FRAME INSPECTION REPORT & DEFECTS LIST

SCHEDULE OF BUILDING DEFECTS

1. Posi Truss Strongback Cut

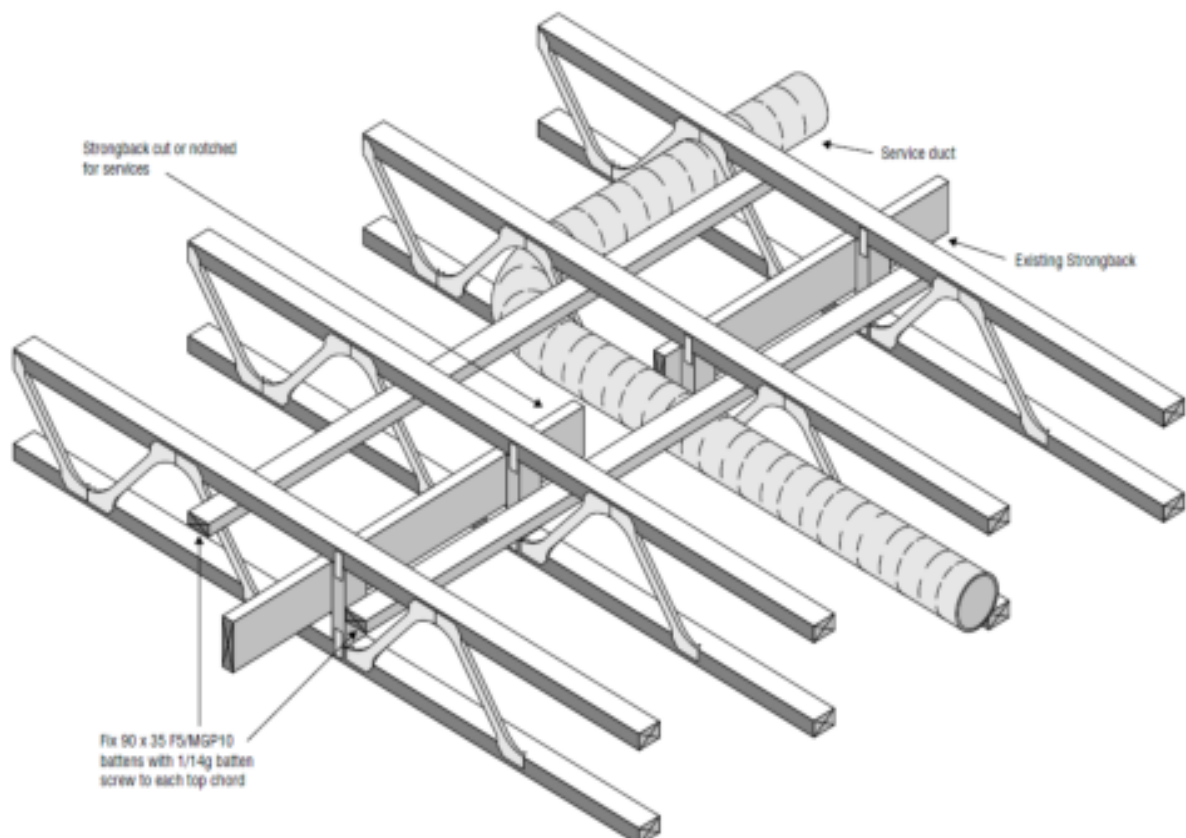
The strongbacks have been cut for services to run through, without any additional framework installed.
Area: Laundry in 2 x areas

The manufacturer states that *'Strongbacks significantly dampen vibrations and increase the stiffness of the floor system. The performance of the floor depends very much on the proper installation of Strongbacks'*.

The manufacturer has a modification detail for this, which states *'Where a strongback has to be cut (or notched) to run a service duct through it, a compensating pair of 90x35 F5/MGP10 battens may be fixed to the underside of the top chord, on each side of the strongback, as shown below. The battens should extend across 3 PosiStrut spacings. Multiple cuts in a strongback should not be less than 3 PosiStrut spacings apart, or additional measures will be required.'*

The additional battens must be installed, or the manufacturer contacted to provide a proper solution.

4. Engineering Item

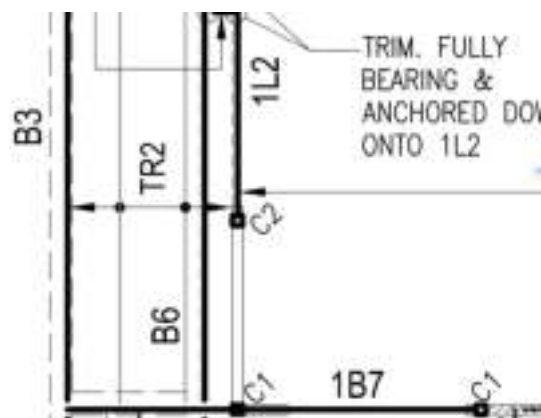
The wall frame and lintel over the living room sliding door frame has been constructed with a double top plate (ribbon plate) which will be supporting roof truss load, despite the note on the engineering drawings stating that it must not carry any load.

This must be rectified prior to works in this area proceeding any further.

7. Posi Truss Strongback to Beam

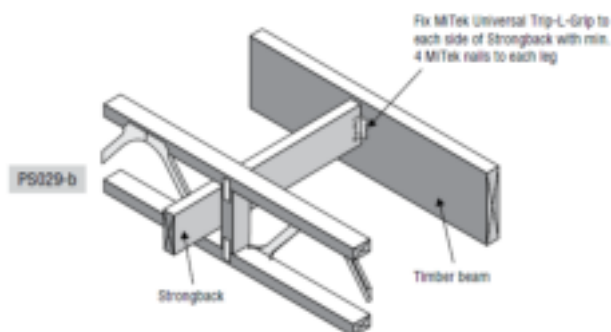
The strongbacks have not been properly fixed to the timber beams.

Area: Study

The manufacturer states that ***'Strongbacks significantly dampen vibrations and increase the stiffness of the floor system. The performance of the floor depends very much on the proper installation of Strongbacks'***.

The strongback must be properly fixed in accordance with the manufacturer's instructions to ensure the performance of the floor frame system.

9. Posi Truss Strongback Span Change

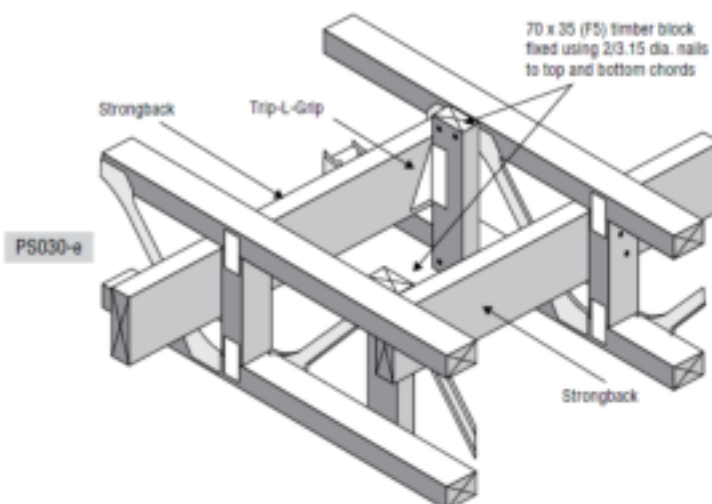
The strongbacks have not been properly connected to the joists at the span changes.
Area: Study & kitchen

The manufacturer states that *‘Strongbacks significantly dampen vibrations and increase the stiffness of the floor system. The performance of the floor depends very much on the proper installation of Strongbacks’*.

The strongback must be properly fixed in accordance with the manufacturer’s instructions to ensure the performance of the floor frame system.

10. Plaster Stud Steel Column

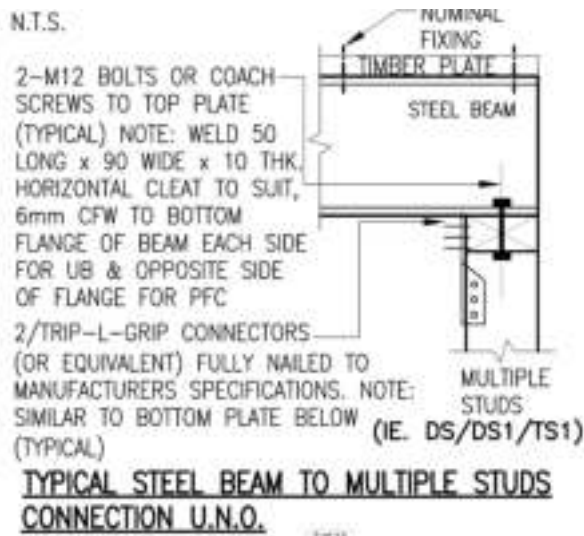
The steel columns have not all been installed to allow for the fixing of the future plasterboard sheets at 300mm centres along the external corners.

Area: Rumpus

The relevant Australian Standard AS 2589.1 Gypsum Linings in Residential and Light Commercial Construction – Application and Finishing, clause 7.6.2 Spacing, requires that ***‘Plasterboard shall be fastened at a maximum of 300mm centres for internal angles, external corners and around openings’***.

This column should have been set back to allow framing members to be attached, to properly support the plasterboard joint at the corners. As the plaster doesn't have the correct support for fixings at 300mm centres, future cracking of the plasterboard in this area is very possible, and should be the ongoing responsibility of the builder into the future, beyond ordinary warranty periods, unless properly addressed.

12. Bottom Plate Unsupported Join

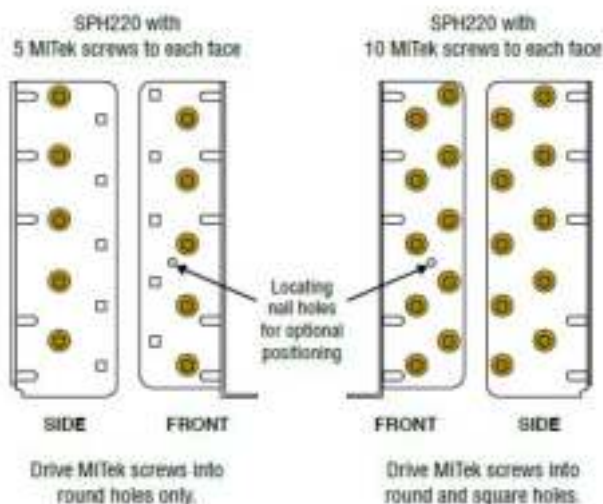
There are joins in the bottom plates that have not been supported by a joist or solid blocking.
 Area: Above ensuite window

The relevant Australian Standard AS 1684 Residential Timber-Framed Construction, clause 6.2.2.2 Bottom Plates states *'Bottom plates may be butt-jointed provided both ends are fixed and supported by floor joists, solid blocking or a concrete slab'*.

This bottom plate join must be properly supported to comply with the above standard.

14. Shear Block Missing

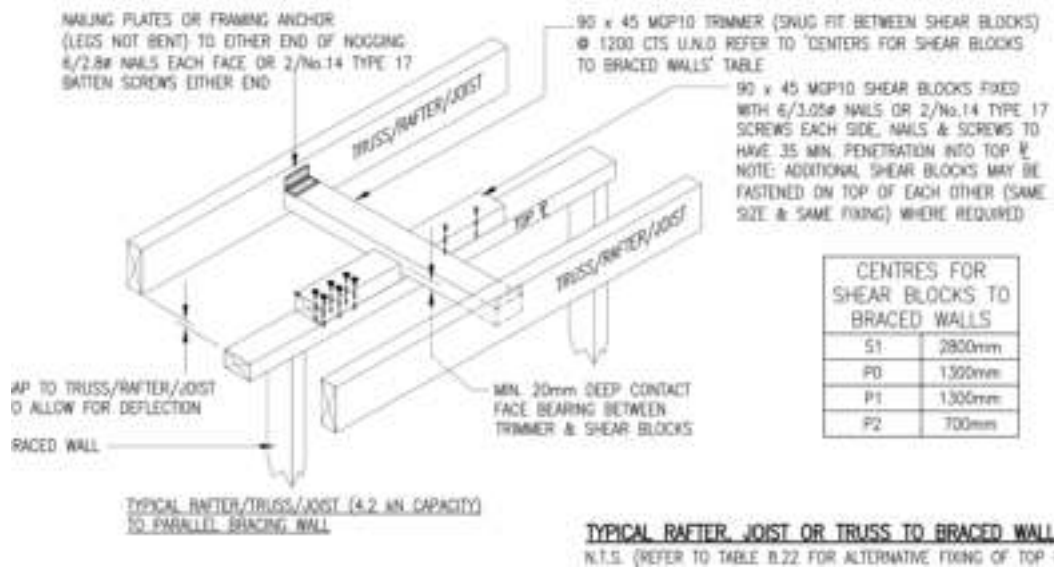
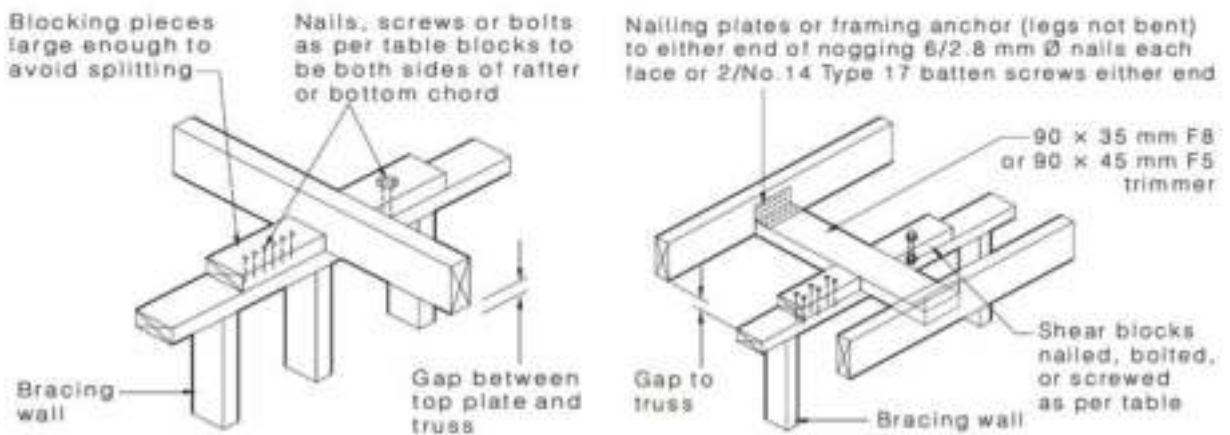
There are shear blocks missing over internal braced walls throughout this home.
Area: Study/laundry wall

The relevant Australian Standard AS 1684 Residential Timber-Framed Construction, clause 8.3.6.9 Fixing of Top of Bracing Walls states that *'All internal bracing walls shall be fixed to the floor of lower storey bracing walls, the ceiling or roof frame, and/or the external wall frame, with structural connections of equivalent shear capacity to the bracing capacity of that particular bracing wall'*.

These missing structural connections must be properly installed to the tops of the internal braced walls in accordance with AS 1684.

15. Nogging Short

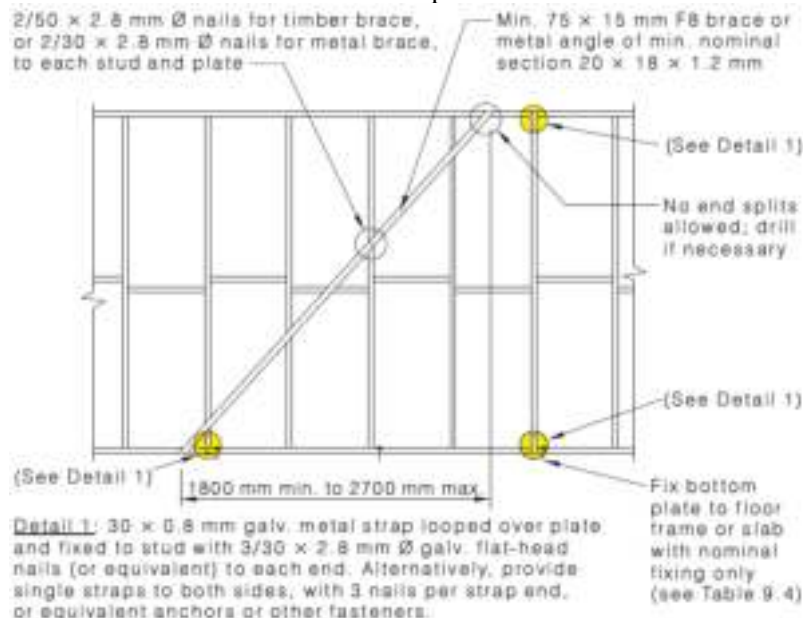
There are noggings between the wall studs that are short, allowing the studs to move behind the plaster sheeting, which could lead to the future cracking of the plaster joints.

Area: Entry/Master wall

The relevant Australian Standard AS 1684 Residential Timber-Framed Construction – Simplified, clause 6.2.1.5 Nogging, states *'Wall studs shall have continuous rows of noggings, located on flat or on edge, at 1350mm maximum centres'*.

All of these wall noggings must be properly installed to be tight between the studs.

17. Engineering Brace Missing

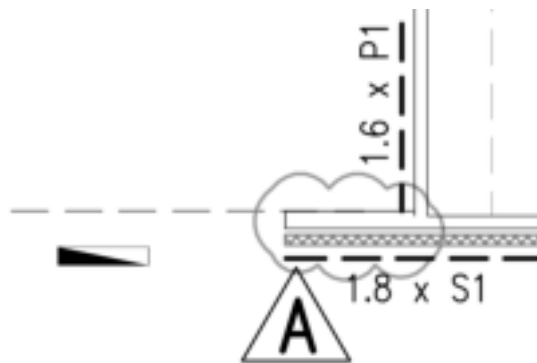
The bracing detailed on the engineering drawings has not been installed as specified.
Area: "S1" brace missing to master/WIR external wall

This will need to be re-constructed on site to reflect the designed requirements of the approved drawings, or otherwise be re-designed and certified by the original design engineer. The building permit may also need to be amended by the relevant building surveyor to reflect the changes to the approved drawings.

18. Nogging Alignment

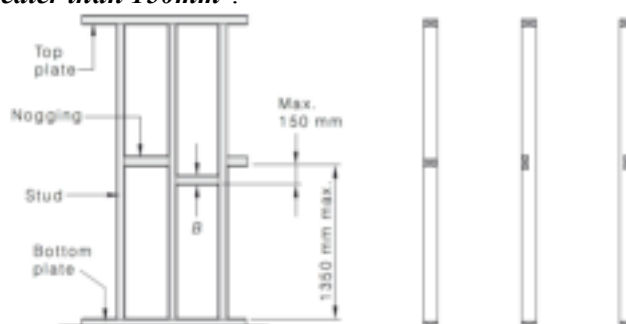
There are wall noggings that are offset or staggered from the ones beside it by up to 500mm.
Area: Laundry

The relevant Australian Standard AS 1684 Residential Timber-Framed Construction, clause 6.2.1.5 Nogging, states '*Noggings may be installed anywhere in the depth of the stud. Stagger in the row of noggings shall be not greater than 150mm*'.

These noggings must be correctly aligned with the abutting ones in accordance with above.

19. Engineering Brace Missing

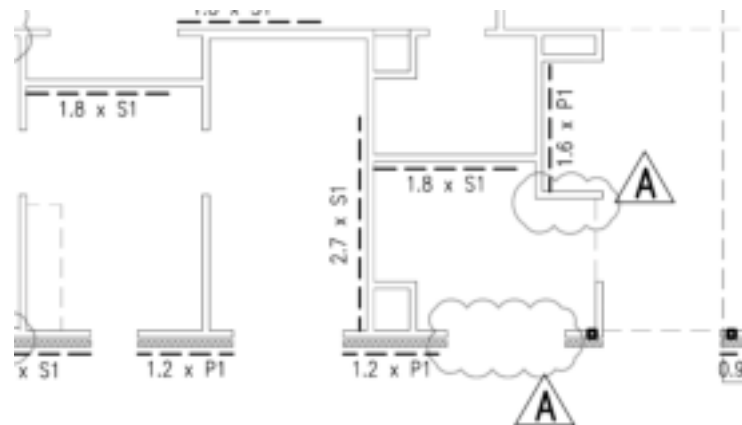
The bracing detailed on the engineering drawings has not been installed as specified.
 Area: "S1" brace missing to Ensuite/pantry wall

This will need to be re-constructed on site to reflect the designed requirements of the approved drawings, or otherwise be re-designed and certified by the original design engineer. The building permit may also need to be amended by the relevant building surveyor to reflect the changes to the approved drawings.

20. Nogging Missing

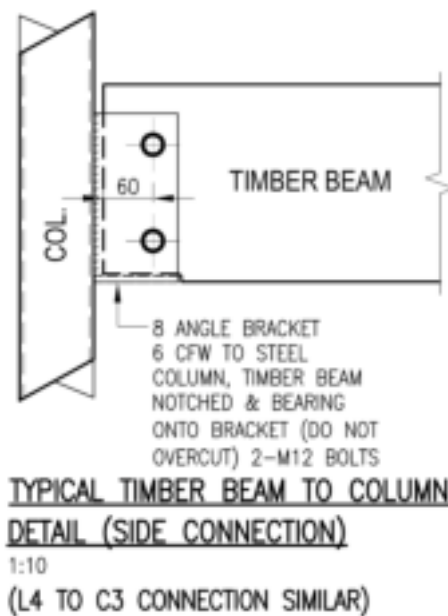
There is a nogging missing between the wall studs, allowing the studs to move behind the plaster sheeting, which could lead to the future cracking of the plaster joints.

Area: Laundry void

The relevant Australian Standard AS 1684 Residential Timber-Framed Construction – Simplified, clause 6.2.1.5 Nogging, states *'Wall studs shall have continuous rows of noggings, located on flat or on edge, at 1350mm maximum centres'*.

All missing wall noggings must be properly installed.

22. Pipe Movement in Frame

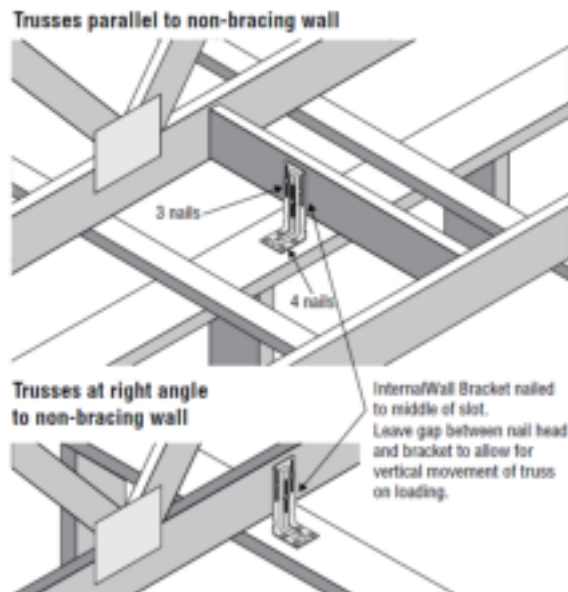
The water pipes need to have silicone or similar installed into the frame holes around the pipe to prevent movement and possible water hammer.

Area: Laundry trough area

The relevant Australian Standard AS 3500 Plumbing and Drainage, Part 1: Water Services, clause 5.4.2 Concealed piping, states that *'Where uninsulated pipes are used, a collar of lagging material or a neutral cure silicone sealant shall be used to fill the annular space'*.

All pipes that run through the frame must be fully secured in accordance with AS 3500.

25. Single Span Flooring

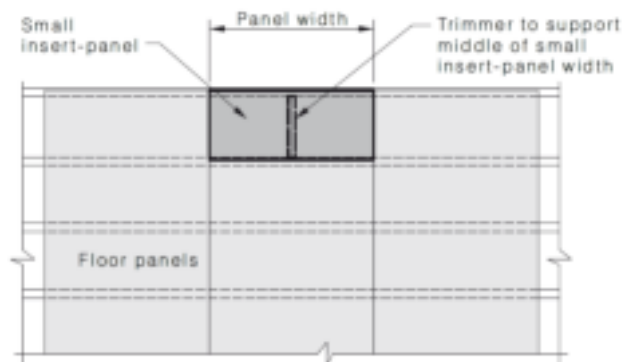
There are areas in the flooring where there is a single span sheet of chipboard flooring only supported by two joists (one spacing), and there has not been any additional framing installed to properly support them.

The relevant Australian Standard AS 1684 Residential Timber-Framed Construction, clause 5.5.4.2 Particleboard Laying states that '*Sheets shall span not less than two floor joist spacings*'.

Although this sheet should not be installed in this manner at all, Australian Standard AS 1860.2 Particleboard Flooring - Installation, clause 9.1 Panel Installation, requires that '*Where possible, each panel shall be supported by not less than three joists. Where this arrangement is not possible, or where small insert-panels are necessary for finishing off the floor area, panels spanning only two joists shall be additionally supported by a trimmer, not less than 70 mm × 35 mm, fixed between these two joists to support the middle of the panel (see Figure 3)*'.

Therefore, these areas must have a trimmer installed between the floor joists to properly support the flooring sheets as required by AS 1860.2

26. Nogging Missing

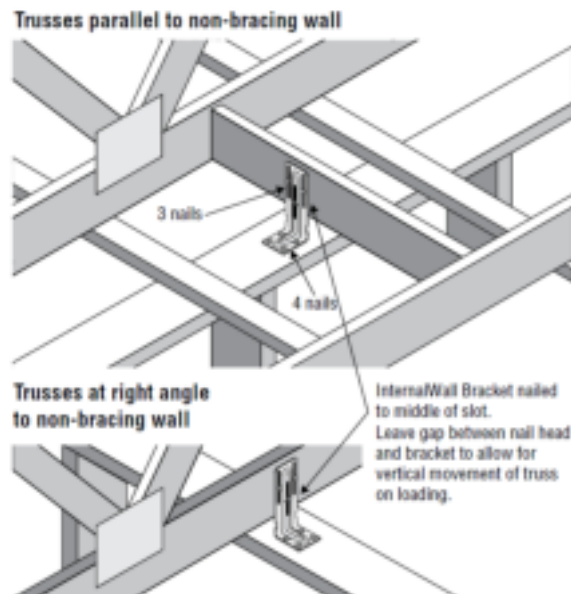
There is a nogging missing between the wall studs, allowing the studs to move behind the plaster sheeting, which could lead to the future cracking of the plaster joints.

Area: Leisure front wall

The relevant Australian Standard AS 1684 Residential Timber-Framed Construction – Simplified, clause 6.2.1.5 Nogging, states '*Wall studs shall have continuous rows of noggings, located on flat or on edge, at 1350mm maximum centres*'.

All missing wall noggings must be properly installed.

31. Stud Holes Oversized

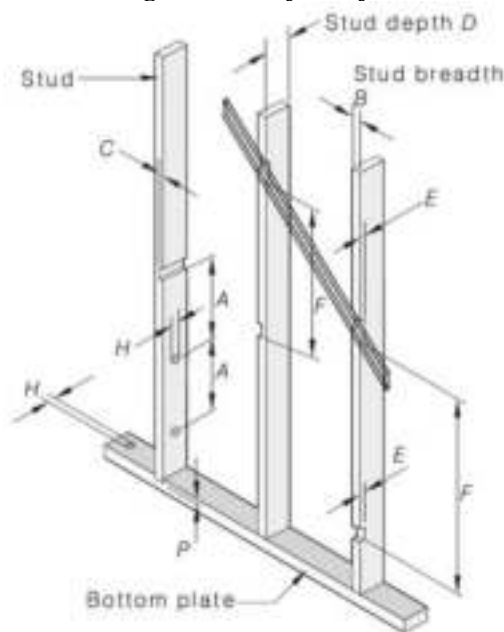
The wall studs have had holes of between 30-70mm drilled through the centre of their 90mm depth for the pipes and/or cables.

Area: Bathroom external wall

The relevant Australian Standard AS 1684 Residential Timber-Framed Construction, clause 6.2.1.4 Notching, Trenching and Holes in Studs and Plates states that *'Holes in studs and plates shall be located within the middle half of the depth and breadth of the member respectively, and that a maximum hole of 25mm in diameter may be drilled through the wide face of a stud'*.

These wall studs will have to be properly strengthened or replaced.

32. Top Plate Holes Oversized

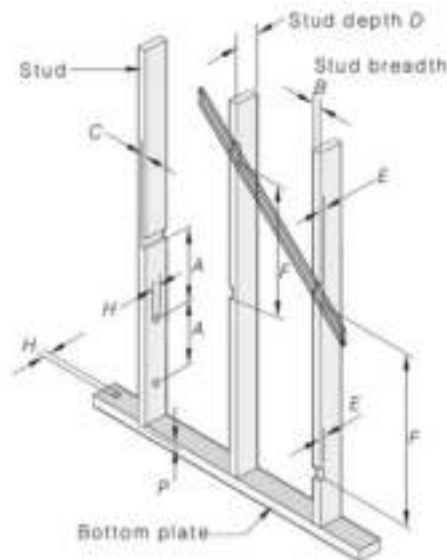
The wall plates have had holes of between 30-70mm drilled through the centre of their 90mm depth for the pipes and/or cables.

Area: Bathroom wall for sewer vent

The relevant Australian Standard AS 1684 Residential Timber-Framed Construction, clause 6.2.1.4 Notching, Trenching and Holes in Studs and Plates states that *'Holes in studs and plates shall be located within the middle half of the depth and breadth of the member respectively, and that a maximum hole of 25mm in diameter may be drilled through the wide face of a plate'*. It also notes that *'Top and bottom plates in internal non-loadbearing and non-bracing walls may be discontinuous up to 60mm (cut or drilled) to permit installation of services provided that, at the discontinuity, the plates are trimmed or otherwise reinforced either side of the discontinuity to maintain the lateral and longitudinal integrity of the wall'*.

These top plates will have to be properly strengthened or replaced.

33. Truss Tie Down (Hips)

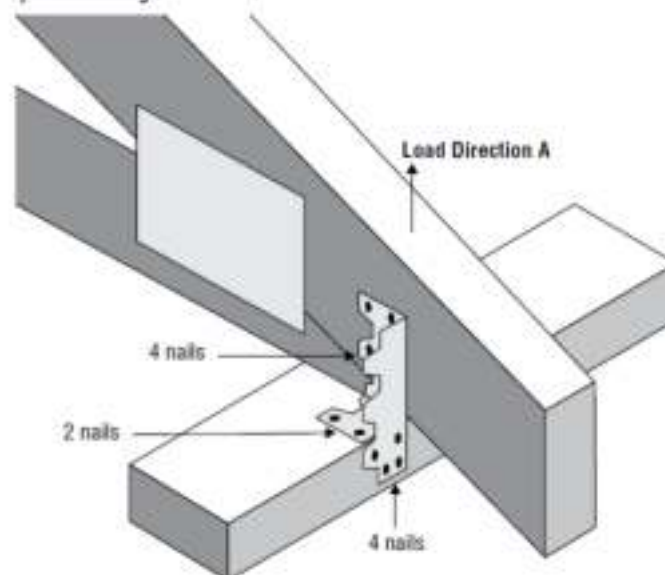
There are trip-l-grips designed to hold down the hip roof trusses throughout this home that have been installed on their flat, which is not the correct orientation.

The truss manufacturer's installation instructions require four nails into the side of the top plates, two into the top of the top plate, and four into the side of the truss, as per their detail below;

These brackets will need to be replaced in the correct orientation, with the appropriate number of nails fitted through each section of the trip-l-grips in accordance with the truss manufacturer's requirements. Alternatively, the builder should provide the owner documentation from the truss manufacturer to confirm that the currently installed brackets are acceptable.

39. Speedbrace Heel Detail

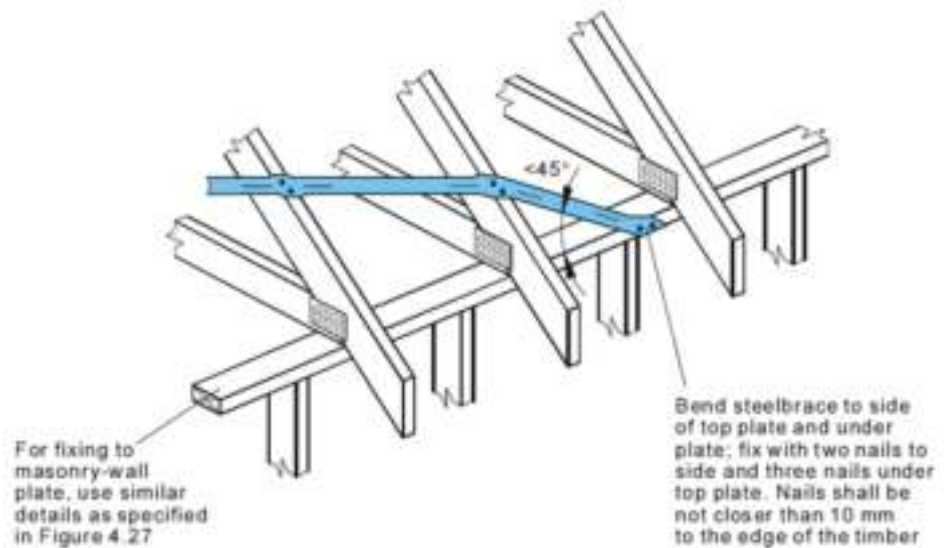
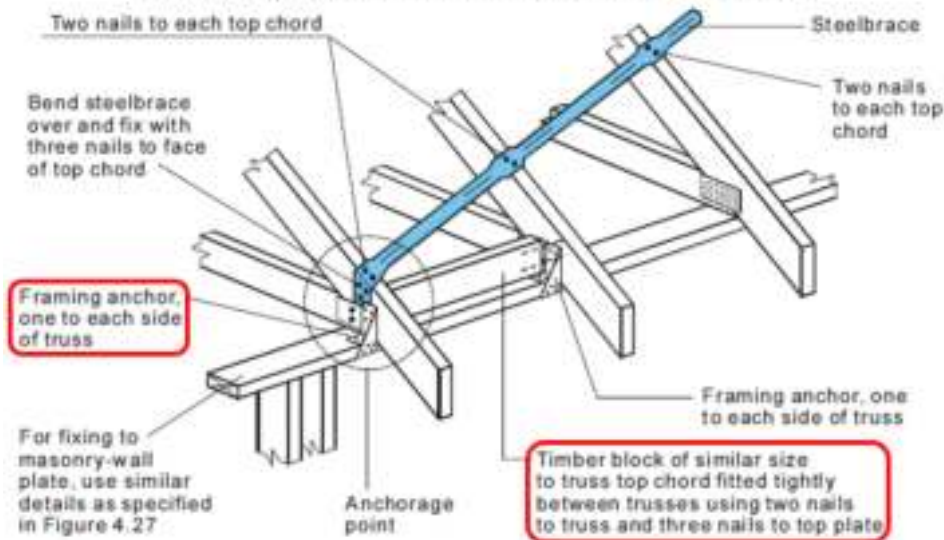
The diagonal speedbracing that runs across the tops of the trusses has not been fixed to the wall top plates at an angle less than 45 degrees, and the alternative fixing detail at the top plate has not been adopted.

Area: Over void near bathroom

The relevant Australian Standard, AS 4440 Installation of Nail-Plated Timber Roof Trusses, clause 4.3.8 Fixing, provides a detail outlining the method for connecting speedbrace to the top plate at the heel;

The fixing of the speedbracing must be rectified in accordance with Australian Standard AS 4440, or if this method is not achievable, then the alternative heel fixing detail shown above must be used.
